Access Compliance Report

Public Rights-of-Way

(Curb Ramps)

Intersection ID: 43739	Main Street: BRIDGEMOUNT_AV	Cross Street: BRIDGEVIEW_LN	Location: NE
ADA ID: 6BE60D1BB01A	Ramp Type: PerpDiag	Initial Pass/Fail: Fail	Overall Compliance: No
Severity Score: 33.75			
Codes/Mitigation Info/Possible Solution		Field Measurements/Component Compliance

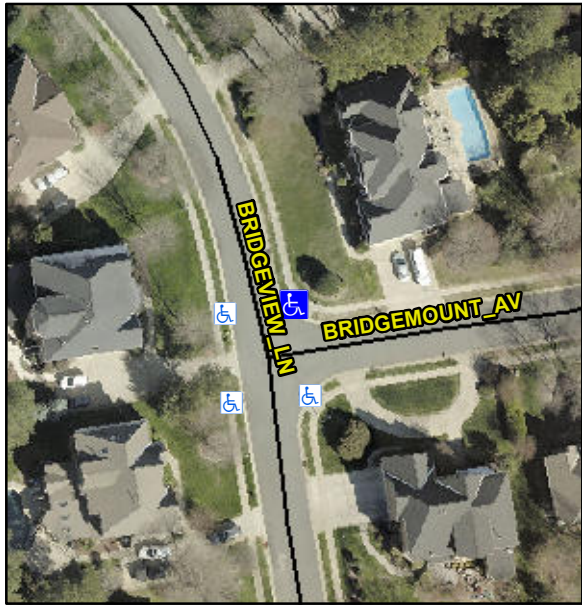
Possible Solutions:				
	Remove & Replace Curb Ramp With Two New Directional Ramps or Equivalent.				
	Surveyor Notes:				
	N/A				
	PROW/ADA:				
	Not Found, R304.5.1, R304.5.3				
Total Cost:		\$	3200.00

Compliance	Description	Data	Compliance	Description	Data
N/A	Ramp Length (in)	48.0	Yes	Ramp Slope (%)	7.1
No	Ramp Width (in)	40.0	No	Ramp XSlope (%)	7.2
N/A	Flare Type LT	N/A	N/A	Flare Type RT	N/A
N/A	Flare Slope LT (%)	N/A	N/A	Flare Slope RT (%)	N/A
N/A	Flare Traversable LT?	N/A	N/A	Flare Traversable RT?	N/A
N/A	Landing Length (in)	N/A	N/A	DWS Provided?	N/A
N/A	Landing Width (in)	N/A	N/A	DWS Contrast?	N/A
N/A	Landing Slope (%)	N/A	N/A	DWS Length (in)	N/A
N/A	Landing X Slope (%)	N/A	N/A	DWS Full Width?	N/A
N/A	Landing Curb? (Y/N)	N/A	N/A	DWS Offset (in)	N/A
N/A	Shared Landing?	N/A			
N/A	Gutter Ponding?	N/A	N/A	Gutter Slope (%)	N/A
N/A	Gutter Lip Ht (in)	N/A	N/A	Gutter X Slope (%)	N/A
N/A	Painted X Walk1?	No	N/A	Painted X Walk2?	No
	X Walk 1 Direction	To W		X Walk 2 Direction	To S
N/A	X Walk 1 Width (in)	N/A	N/A	X Walk 2 Width (in)	N/A
	X Walk 1 Slope (%)	0.4		X Walk 2 Slope (%)	5.4
	X Walk 1 X Slope (%)	4.5		X Walk 2 X Slope (%)	2.8

N/A	Ramp inside XWalk1?	N/A	N/A	Ramp inside XWalk2?	N/A
	Road Slope (%)	5.1	N/A	Clear Space?	N/A
	Road X Slope (%)	2.0	N/A	Clear Space to XWalk (in)	N/A
N/A	Any Obstructions?	N/A	N/A	Storm Grate/Utility Hazard?	N/A
	Obstruction Type			Storm Grate/Utility Type	
		N/A			N/A
			Yes	Surface Condition? (G/P)	Good
